DART SERVICE INSTRUCTION

TO AMEND INSTALLATION INSTRUCTIONS D350-602 REV E (OR EARLIER REV.)
AND INSTRUCTIONS FOR CONTINUOUS AIRWORTHINESS ICA-D350-602 REV. 0

LUG UPGRADE KIT

FIGURE 1: Aft Crosstube Attachment
(Installation of D4091-1 / D3910-3 Lugs)

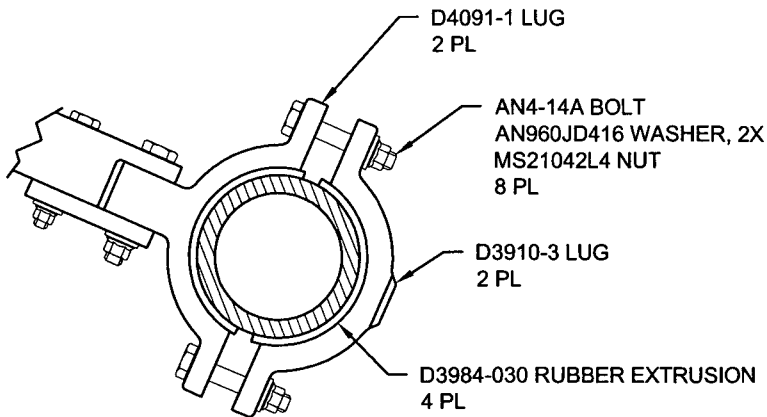
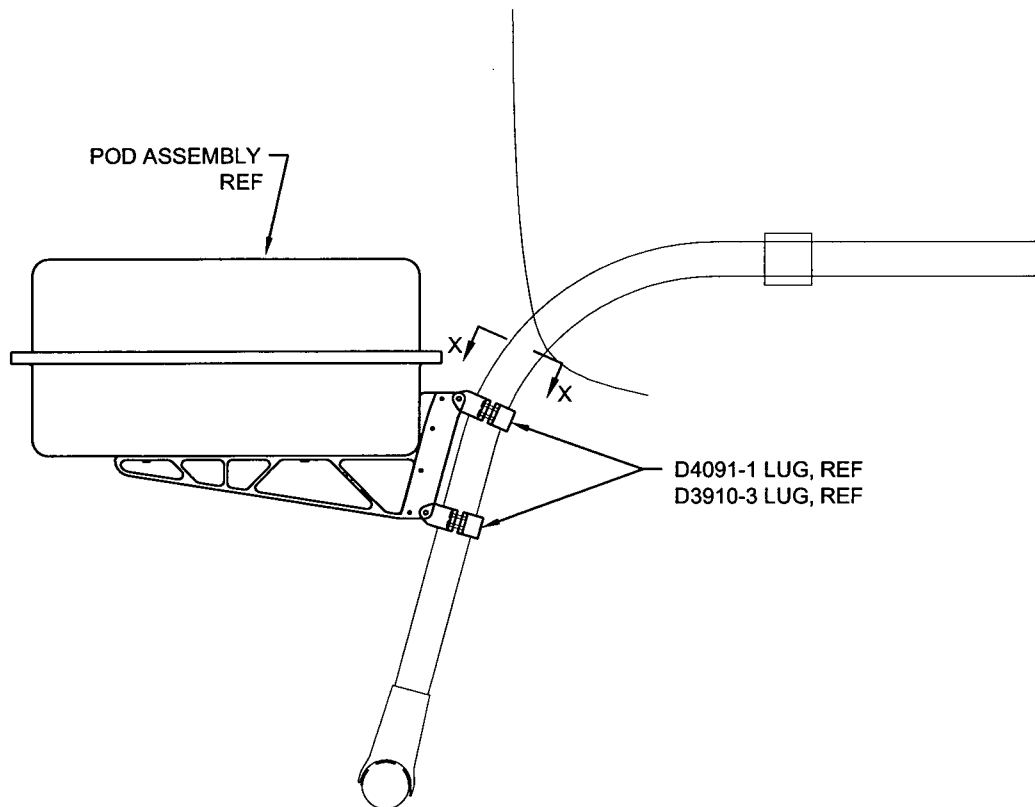
The D2230-1/-3 clamps are replaced with wider D4091-1/D3910-3 lugs. The abrasion strip is replaced with D3984-030 rubber extrusion. The D2462-1700 Neoprene Seal is replaced with D2461-1700 Neoprene 'D' Seal. The modified parts list for Installation Instruction D350-602 and Instructions for Continued Airworthiness ICA-D350-602 is shown on sheet 2 of this service instruction. Install the lugs as shown in Figure 1 & 2 of this service instruction. The pod should otherwise be installed per D350-602 and maintained per ICA-D350-602.

The Dart DSI-9515-011 kit is available to upgrade D350-602-XXX Heli-Utility-Pods made to earlier change numbers with D4091-1 / D3910-3 lugs. The lugs should be installed per Figure 1 & 2 of this service instruction.
